TOWN OF JACKSON

AGENDA DOCUMENTATION

SUBJECT: **ITEM P18-156:** DEVELOPMENT PLAN FOR A NEW PLANNED MIXED USE BUILDING CONTAINING COMMERCIAL SPACE, SHORT TERM RENTAL UNITS, AND EMPLOYEE HOUSING LOCATED WITHIN THE LODGING OVERLAY AND COMMERCIAL RESIDENTIAL-ONE (CR-1) (LO) ZONING DISTRICT.

APPLICANT: Y2 CONSULTANTS, SCOTT PIERSON

Trash/Snow Storage/Bicycle Parking

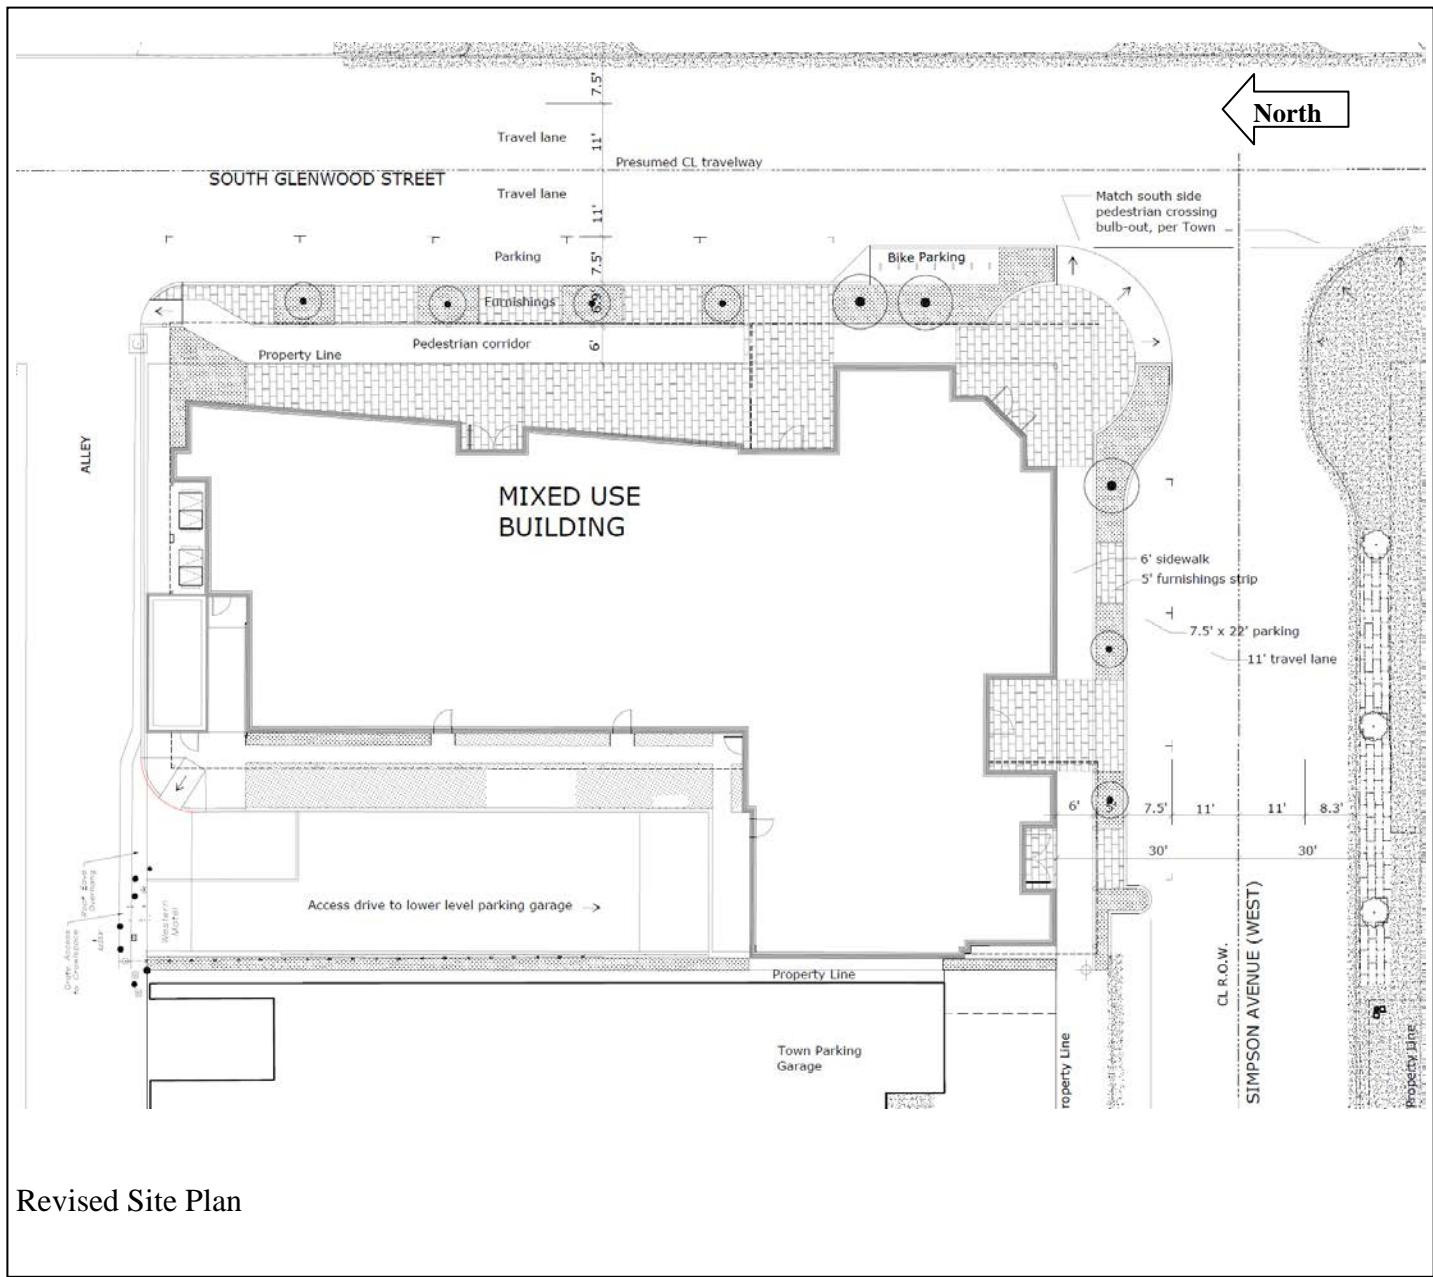
Trash and Snow: Service areas are consolidated, and trash and recycling areas are incorporated in enclosed areas along the alley. Snow storage is proposed adjacent to the curb on both Simpson and Glenwood in a five foot buffer comprised of sandset pavers. Proposed cantilevered canopies directed towards the building will provide cover and help keep walkways snow free.

The applicant had previously proposed 12 bicycle parking spaces in the form of a U-rack style parking structure adjacent to the curb on both Simpson and Glenwood as well as adjacent to the employee housing units on the west. The revised site plan submitted on August 14, 2018, and shown below indicates bicycle parking in a centralized location adjacent to the edge of the curb on the bulb-out. Pathways Coordinator Brian Schilling has already provided detailed comments in his departmental review of appropriate bicycle parking locations and standards for both short and long term parking. As a condition of approval, Staff recommends that prior to Building Permit submittal, the applicant shall consult with and gain approval from the Pathways Director the appropriate location of bicycle parking spaces.

The wording of Condition Number 4 has been changed to “Prior to Building Permit submittal, the applicant shall consult with and gain approval from the Pathways Director to determine the appropriate location of bicycle parking.” This change has been made in order to provide the applicant and the Pathways Director flexibility since there have been revisions to the pedestrian frontage which may provide better opportunities for the location of bicycle parking and since the Pathways Director has not yet had a chance to review the revised site plan’s proposed bicycle parking location.

Revised Site Plan

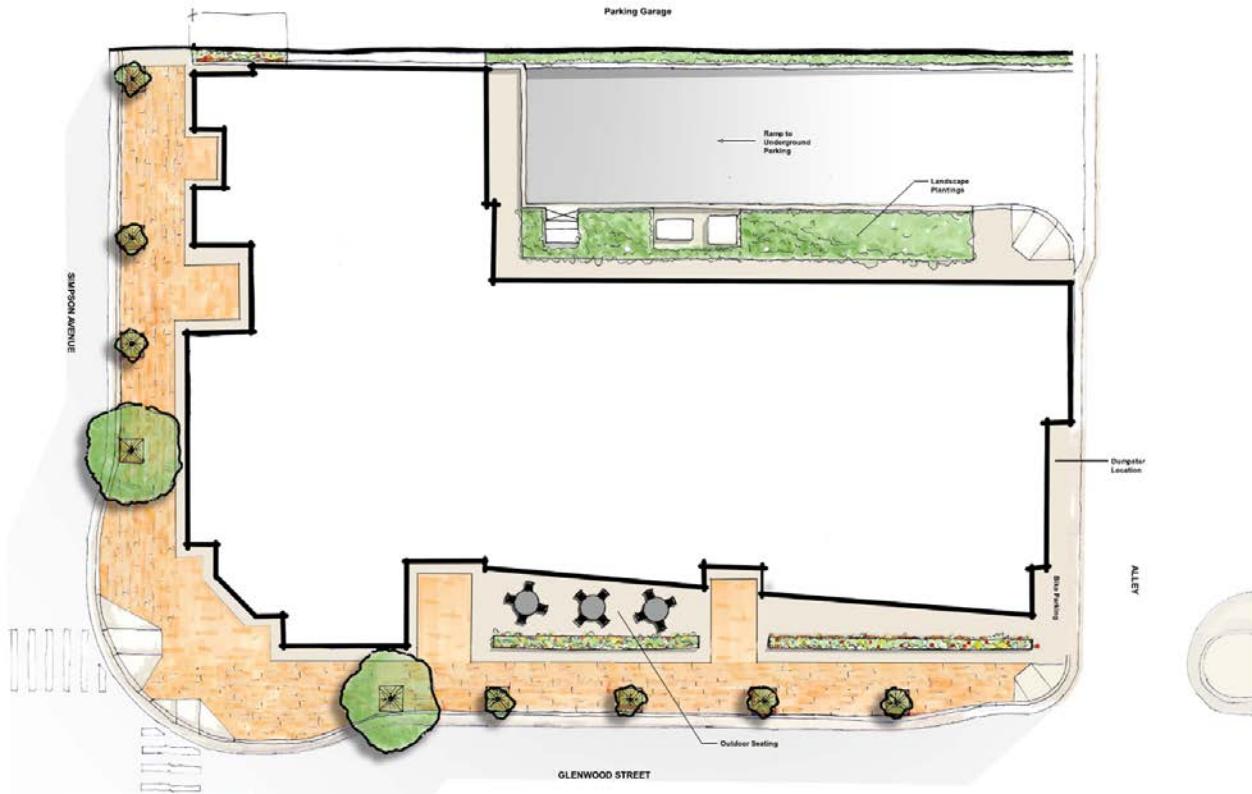
The changes made to the streetscape include:

- A 6' wide unobstructed pedestrian corridor around the perimeter of the building where support columns for the canopy were previously obstructing
- A buffer to protect the loading zone and ride-to-fly bus stop
- The expansion of the sandset pavers from 4' to 5' to accommodate tree grates; and
- The alignment of the bulb-out with the bulb-out across Simpson Avenue at the Marriott.

The Town Engineer had discussed with the applicant the need for a 23' width between bulb-outs where the applicant has shown 22'. In addition, the on-street parking on Glenwood has been pushed back to accommodate the expanded bulb-out, however this results in an on-street parking space directly adjacent to the alley entrance. Should the Town Engineer require, the applicant may need to reduce their on-street parking by one space to provide a red-curb at the entrance to the alley in order to maintain clear sightlines. As of the date of this report the Town Engineering and the Pathways Coordinator have not had a chance to review the revised streetscape proposal, however as a condition of Public Works' departmental review the applicant will be required to provide a Pedestrian Corridor Plan prior to Building Permit approval which includes all dimensions and elevations in relation to existing curbs, future development, and demonstrate ADA compliance. Planning Staff has reviewed the proposal against the PMD Master Plan and finds that the overall function of the sidewalk is compatible with the current LDR form standards and that the applicant has responded adequately to Staff's previous concerns. All changes will require approval by Planning, Public Works, and the Pathways Coordinator at time of Building Permit. As a condition of approval, Staff recommends that the final Pedestrian Corridor Plan shall demonstrate a clear 6 foot unobstructed pedestrian corridor around the entirety of the building as measured from the building to any support column.

The applicant will be providing both a covered walkway as well as trees in grates along the streetscape. The covered walkway alternates between support columns for the second floor balconies on the northeast portion of the site on Glenwood and the southwest portion of the site on Simpson with a cantilevered awning around the main entrances of the building near the bulb-out. The sandset pavers are a change from the originally approved 2006 FDP plan which was formerly greenspace planted area to match the Center for the Arts across the street, however this was changed in response to Public Works' concerns for adequate snow storage. Staff finds that the pedestrian frontages meet the intent and standards of the LDRs and the Comprehensive Plan.

4. The final Pedestrian Corridor Plan shall demonstrate a clear 6 foot unobstructed pedestrian corridor around the entirety of the building as measured from the building to any support column.
